# CHANGE ORDER

**PROJECT:**  
 Precint 2 - Mobility Projects  
 Brand Lane - From Avenue E to US90A  
 Fort Bend Count Project 718-769

CHANGE ORDER NUMBER .....	4
DATE .....	12-14-15
PROJECT NUMBER .....	718/769
	Fort Bend County
CONTRACT FOR .....	
CONTRACT DATE .....	10-1-14
FBC PURCHASE ORDER NO .....	116140

**FORT BEND COUNTY PROJECT 718/769**  
**BRAND LANE - FROM AVENUE E TO US90A**  
**Change Order 4 - Option A for Bore Under Highway 90**

Original Plan

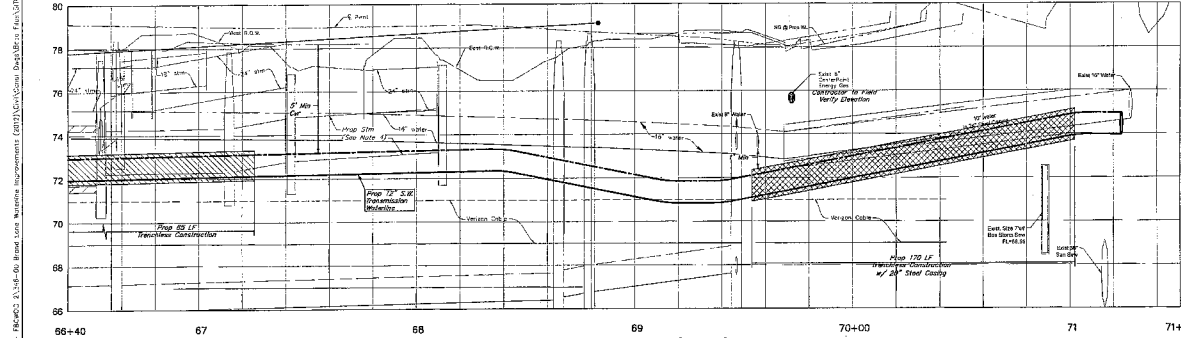
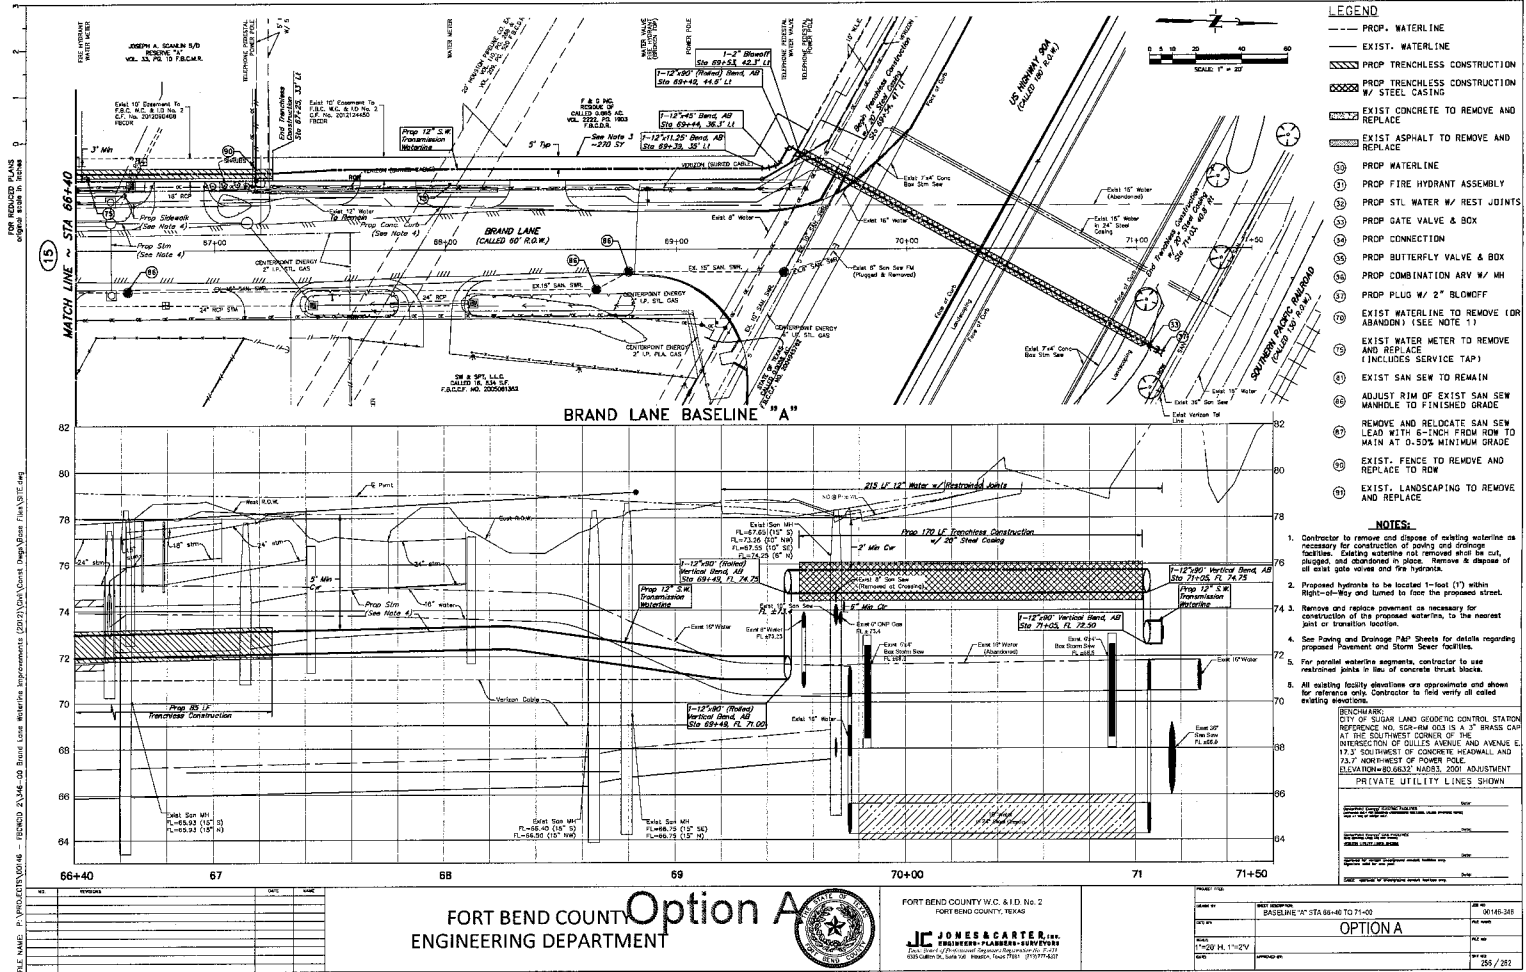
The contract is changed as follows:  
 Revised 12" SW Transmisson plans to follow new "Option A Plan." The reason for the change is that an existing 16" waterline was verified to be 2 feet lower than original plans determined. The elevation of the waterline has been revised per Option A Plans. Please see attached plans original and Revised Option A.

**Option A**
